UNITED STATES PATENT AND TRADEMARK OFFICE

| APPLICATION NO. | FILING DATE | FIRST NAMED INVENTOR | ATTORNEY DOCKET NO. | CONFIRMATION NO. |
|-----------------|-------------|-------------------------|---------------------|------------------|
| 10/051,433 | 01/18/2002 | Geoffrey Hamilton White | PAT-1285DIV | 5904 |

| Office Action Summary | Application No. | Applicant(s) | |

DETAILED ACTION

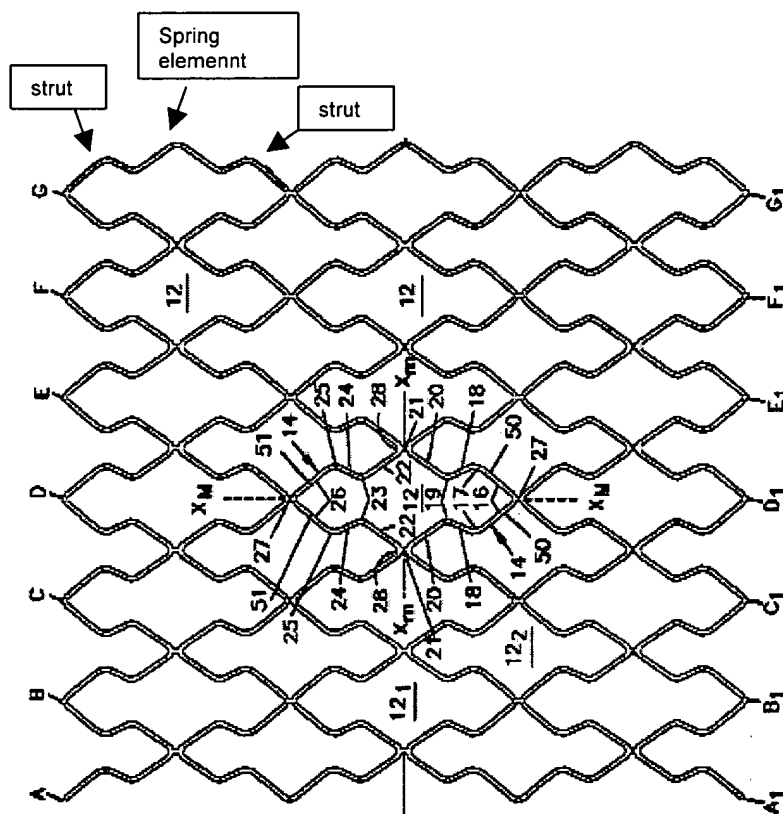
Claims 23-26, 29, 31-37, 40, 42-49, 52, 54-60, 63, 65-67 are rejected under 35 U.S.C. 103(a) as being unpatentable over Thompson (6132460). Fig. 3 shows a stent with a plurality of cells defining longitudinal rows (B-G) where adjacent longitudinal rows are inversely symmetrical to other longitudinal rows. It can be seen that adjacent cells are directly connected to an adjacent cell and cells are formed of exactly four struts.

The cells have at least four bends extending outside the cell and since claims 29,40,52,63 do not recite only or exactly four bends extend outside the cell, Thompson's cells with more than four bends extending outside the cell meet the limitation. However, Thompson does not disclose the plurality of cells being non-symmetrical about the longitudinal axis. It would have been an obvious matter of design choice to modify the cell symmetry, since applicant has not disclosed that using non-symmetrical structure provides any advantage, or solves a stated problem, or is used for any particular purpose. One of ordinary skill in the art, furthermore, would have expected Applicant's invention to perform equally well with the cell pattern taught by Thompson or the claimed cells being non-symmetrical about the longitudinal axis in claim(s) 23-26,29,31-37,40,42-49,52,54-60,63,65-67 because both Thompson's cells and the claimed non-symmetrical cells perform the same function of being highly flexible before and after expansion.

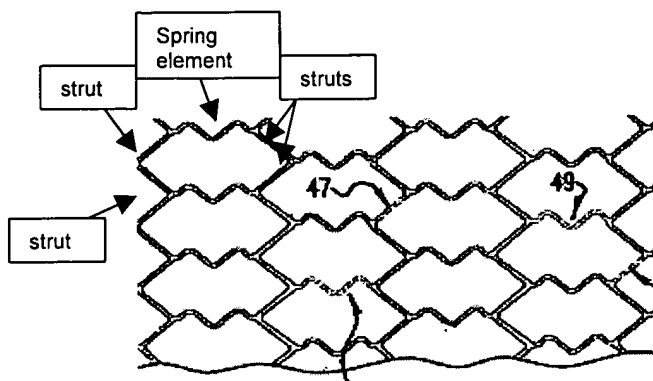
Claims 23-26,28,29,31-37,39,40,42-49,51,52,54-60,62,63,65-67 are rejected under 35 U.S.C. 103(a) as being unpatentable over Roubin et al. (WO 98/34668). Fig. 9 shows a stent with a plurality of cells defining longitudinal rows, wherein adjacent longitudinal rows are inversely symmetrical to other longitudinal rows. It can be seen that adjacent cells are directly connected to an adjacent cell and cells are formed of exactly four struts. The cells have at least four bends extending outside the cell and since claims 29,40,52,63 do not recite only or exactly four bends extend outside the cell, Roubin's cells with more than four bends extending outside the cell meet the limitation.

However, Roubin et al. do not disclose the plurality of cells being non-symmetrical about the longitudinal axis. It would have been an obvious matter of design choice to modify the cell symmetry, since applicant has not disclosed that using non-symmetrical structure provides any advantage, or solves a stated problem, or is used for any particular purpose. One of ordinary skill in the art, furthermore, would have expected Applicant's invention to perform equally well with the cell pattern taught by Roubin et al. or the claimed cells being non-symmetrical about the longitudinal axis in claim(s) 23-26,28,29,31-37,39,40,42-49,51,52,54-60,62,63,65-67 because both Roubin's cells and the claimed non-symmetrical cells perform the same function of being highly flexible before and after expansion.

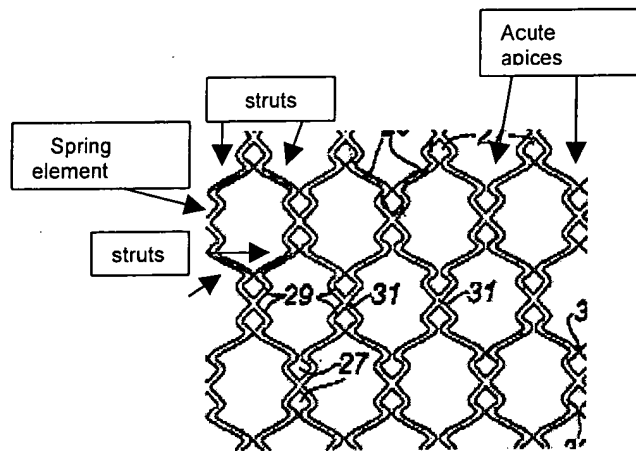
Claims 23,24,26,27,29-32,34,35,37,38,40-43,45-50,52-55,57-59, 61,63-66 are rejected under 35 U.S.C. 103(a) as being unpatentable over Milo (6206911). Fig. 2 shows a stent with a plurality of cells defining longitudinal rows, wherein adjacent longitudinal rows are inversely symmetrical to other longitudinal rows. It can be seen that adjacent cells are directly connected to an adjacent cell and cells are formed of exactly four struts. The cells have at least four bends extending outside the cell and

since claims 29,40,52,63 do not recite only or exactly four bends extend outside the cell, Milo's cells with more than four bends extending outside the cell meet the limitation.

The cells have at least three bends defining acute apices or internal angles that are less than ninety degrees. Since claims 27,30,38,41,50,53,61,64 do not recite only or exactly three bends with acute angles, Milo's cells having four acute angles meet the claim limitations. However, Milo does not disclose the plurality of cells being non-symmetrical about the longitudinal axis. It would have been an obvious matter of design choice to modify the cell symmetry, since applicant has not disclosed that using non-symmetrical structure provides any advantage, or solves a stated problem, or is used for any particular purpose. One of ordinary skill in the art, furthermore, would have expected Applicant's invention to perform equally well with the cell pattern taught by Milo or the claimed cells being non-symmetrical about the longitudinal axis in claim(s) 23,24,26,27,29-32,34,35,37,38,40-43,45-50,52-55,57-59, 61,63-66 because both Milo's cells and the claimed non-symmetrical cells perform the same function of being highly flexible before and after expansion.
